## **DMC-50747NF-AK LCD MODULE TECHNICAL NOTE**

**TN-DMC-50747-01**

**0.0**

**2004/06/06**

Figure 1 -- Block Diagram of Power Supply

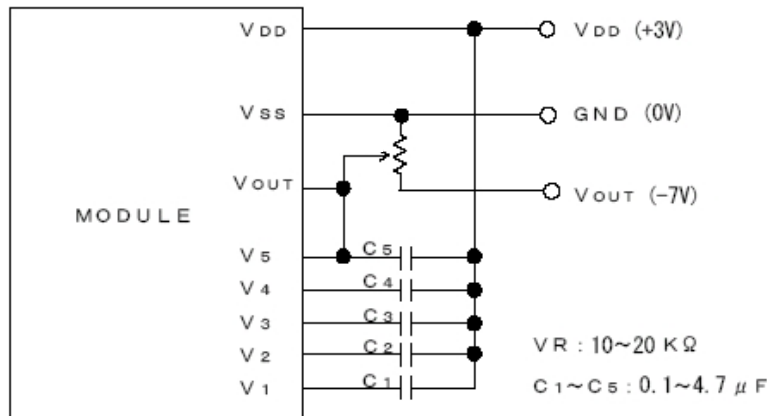
- 3.1. The Section 4.2 Example of Power Supply is not correct. Please refer to Figure 1 for the correct hookup. By varying the potentiometer, LCD contrast can be controlled. Please note that this setup is shown at the bottom of page 4-20 of reference (c) for the instance of 'External Power Supply.'

It is recommended to apply a potentiometer for the contrast adjust due to the tolerance of the driving voltage and its temperature dependence.

Both the boosting circuit and the voltage control circuit are not used in this module.  
Therefore, connect V5 pin with VOUT pin and supply the LCD driving voltage from the outside.
